# UNITED STATES PATENT AND TRADEMARK OFFICE

10/593,303

<b>Office Action Summary</b>	<b>Application No.</b> 10/593,303	<b>Applicant(s)</b> VAN MOL ET AL.	
	<b>Examiner</b> WALTER H. SWANSON	<b>Art Unit</b> 2823

## **DETAILED ACTION**

FIG. 1

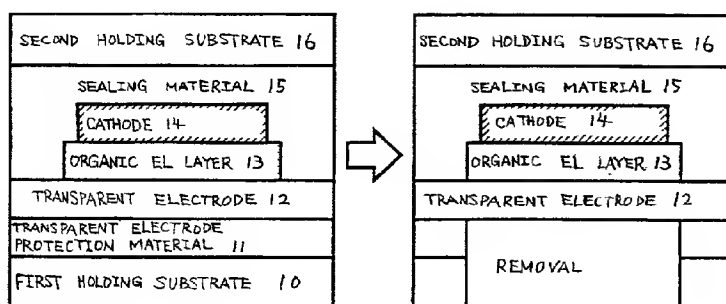
Tsutsui discloses a method for preparing a flexible organic electronic device comprising at least a first electrode (12) comprising a transparent conductive oxide layer (ITO col. 2, [0029]), an organic active layer (13), a second electrode (14) and a polymeric substrate layer (16; col. 2, [0034]), whereby the transparent conductive layer (12) is applied on a removable substrate layer (10) or one or more transparent layers previously applied onto the removable substrate layer (10) at a temperature of at least 250°C, and the removable substrate layer (10) is removed when the polymeric substrate layer (16) has been applied (FIG. 1).

Tsutsui discloses applying the transparent conductive layer by a high-temperature sputter deposition process. Tsutsui discloses the claimed invention except for applying a transparent conductive layer at a temperature of at least 250°C. It would have been obvious to one having ordinary skill in the art at the time the invention was made to apply a transparent conductive layer at a temperature of at least 250°C, since it has been held that where the general conditions of a claim are disclosed in the prior art, discovering the optimum or workable ranges involves only routine skill in the art. *In re Aller*, 105 USPQ 233 (CCPA 1955).

- a) applying the first electrode (12), which comprises a transparent conductive oxide layer (ITO) onto the removable substrate layer (10) or on one or more transparent layers (11) previously applied onto the removable substrate layer (10) (FIG. 1);
  - b) applying the organic active layer (13) onto the transparent conductive layer (12) (FIG. 1);
  - c) applying the second electrode (14) onto the organic active layer (13) (FIG. 1);
  - d) applying the polymeric substrate layer (16) onto the second electrode (14) (FIG. 1);
- and

e) removing the removable substrate layer (10) (FIG. 1).

a) applying the first electrode (12), which comprises a transparent conductive oxide layer (ITO) onto the removable substrate (10) (FIG. 1);

b) applying one or more transparent layers (13) onto the transparent conductive oxide layer (ITO) (FIG. 1);

c) applying the polymeric substrate layer (16) onto the transparent conductive layer (ITO) (FIG. 1);

d) removing the removable substrate layer (10) (FIG. 1);

f) applying the second electrode (14) onto the organic active layer (13) (FIG. 1); and

g) applying a further polymeric substrate layer onto the second electrode (14) (FIG. 1).
